RESPONSE TO PUBLIC EXHIBITION

**Proposed Rural Residential Subdivision-Lot 2 DP 250984
Grandfathers Gully Road Lilli Pilli.**

(A) Response to Department of Planning key issues identified subsequent to the exhibition of the proposed rural residential subdivision at Lot 2 DP 250984 Grandfathers Gully Road Lilli Pilli. MP 06 0125

Plate 1: Regeneration of Coastal Lowlands Cycad Dry Shrub Forest near Batemans Bay.

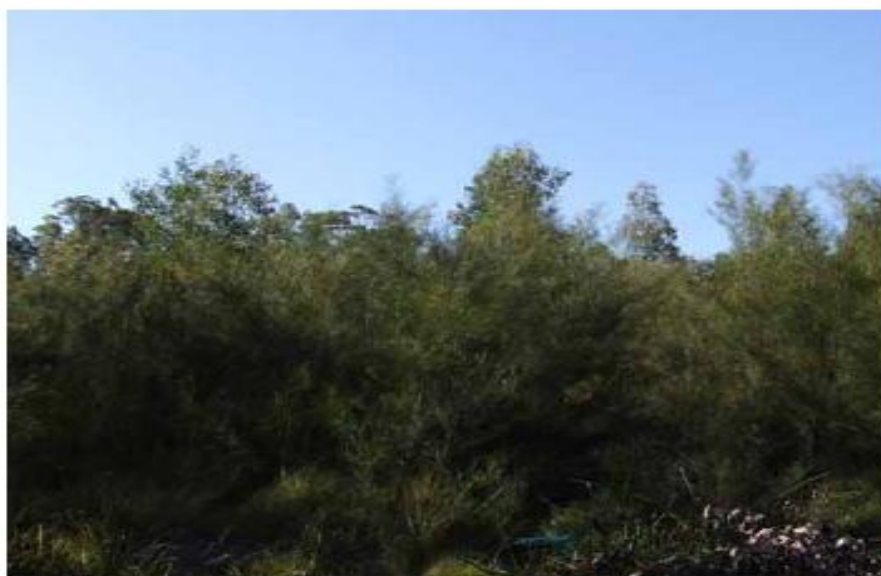
On top of this there needs to be an understanding of the natural regeneration process in the Eurobodalla area. NGH have provided the following comments (see attachment 5):

*“The subject land is situated on Ordovician metasediments with the existing vegetation species being typical of the region on clay soils. This vegetation consists of species derived from Coastal Lowlands Cycad Dry Shrub Forest (Forest Ecosystem 9 in Thomas et al 2000) on the ridge and upper slopes, tending towards Northern Foothills Moist Shrub Forest (Forest Ecosystem 21) in the gullies and lower parts of the site. In both these communities the dominant tree is spotted gum (*Corymbia maculata*) with blackbutt (*Eucalyptus pilularis*), white stringybark (*E. globoidea*) and grey ironbark (*E. fibrosa*). Small trees consist largely of black sheoak (*Allocasuarina littoralis*) and wattles, *Acacia mabellae*, *A. longifolia*, *A. mearnsii* and *A. implexa*. The understorey is drier in the Cycad Dry Shrub Forest and includes burrawang (*Macrozamia communis*) and shrubs including *Acacia stricta*, *Acacia terminalis*, *Hibbertia aspera*, *Daviesia ulicifolia*, *Leucopogon lanceolatus* and *Bursaria spinosa*.*

The existing clearing of the site comprises of numerous shrubs, which due to repeated slashing of the land, are unable to grow in a natural form and exist as prostrate or as low height shrubs. Numerous vines and creepers are also present in the existing clearings. These features would indicate, that in the absence of frequent slashing of the ground vegetation, that it would infact, naturally regenerate. Evidence to support the process of natural regeneration being relevant to the subject land comes from a site also in the Batemans Bay area. Clearing of the same vegetation community occurred approximately six years ago, and in the absence of site development or slashing, this vegetation has naturally regenerated to between 3-4 metres in height (Plate 1).”

Common sense would dictate that the APZ areas will be established by individual owners. Clearing methods for these are proposed to be specified in the 88B instruments. Basically as existing trees would be retained in the APZ's especially in the outer protection zones. The approach adopted in respect of vegetation management for the proposed 13 lot subdivision is considered to be rigorous.
